P/N: 1013-005-201-0	SEQ #	MTL: 4340 AT 34-38 Rc
			DATE: 08-30-13	BY: RHJ	110
			FILE:		
REV	DISCRIPTION	BY	DATE	UNLESS OTHERWISE SPECIFIED:	FILLET: .020/.040
-	INITIAL RELEASE	RHJ	08-30-13	PART NAME: DOOR ROD CLEVIS	EDGES: .015 MAX
			FINISH: 125

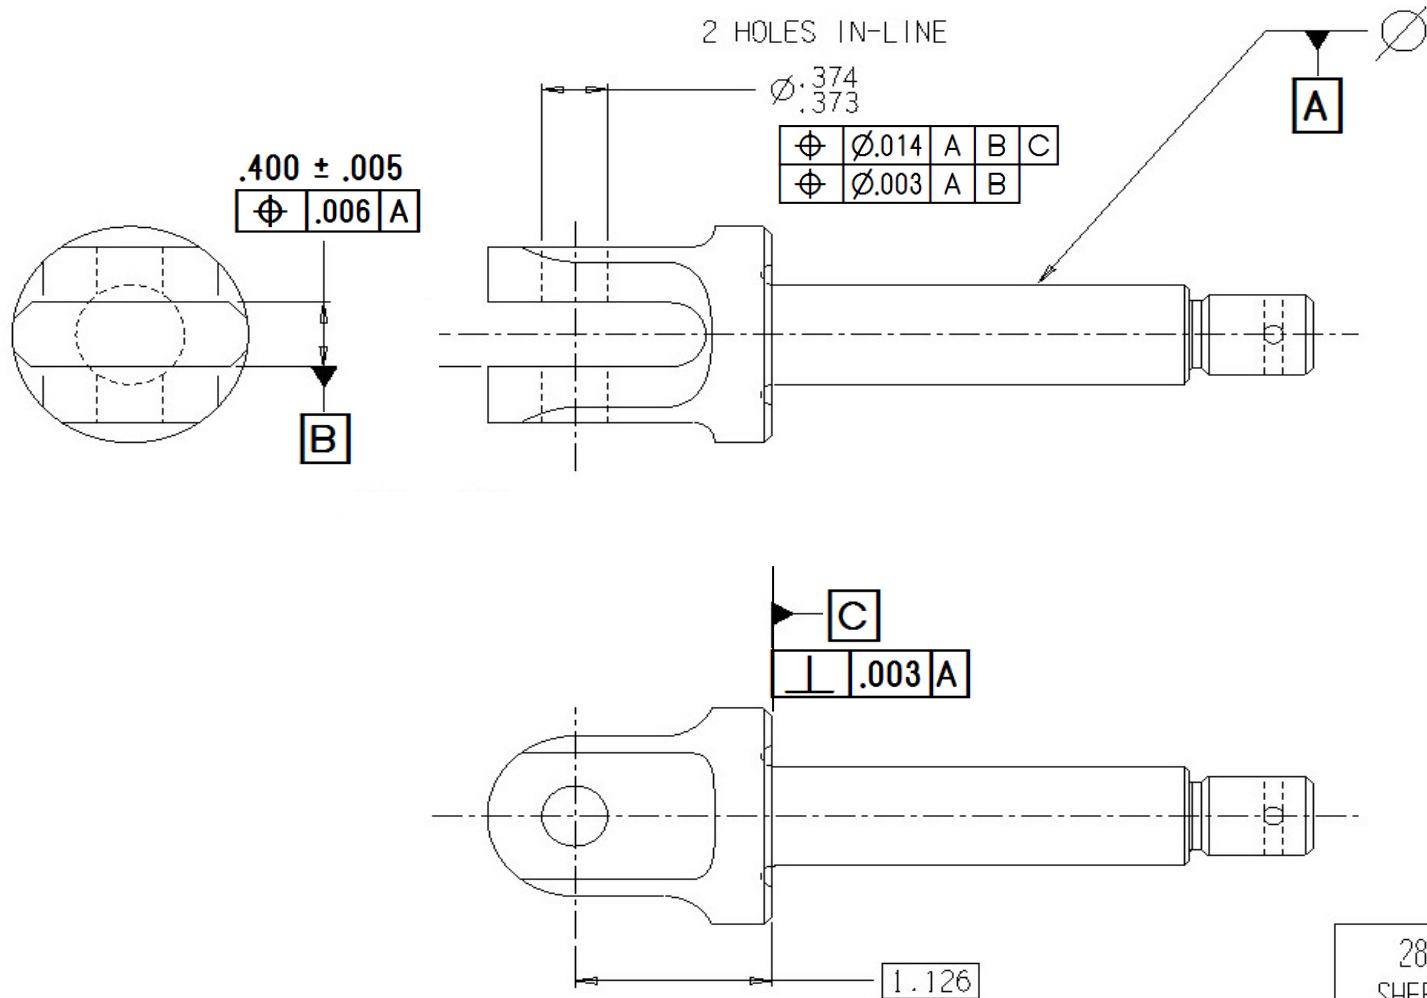
- I have tried several types of composite boxes, but none seem to describe what I want, or at least they dont look right to me.
My intent is to have the .375 dia have a position tolerance of .014 from datum -a- but .003 from centerline of datum -b-.
I also want an orientation tolerance of .003 for perp to -a- and perp to -c-.
What would that
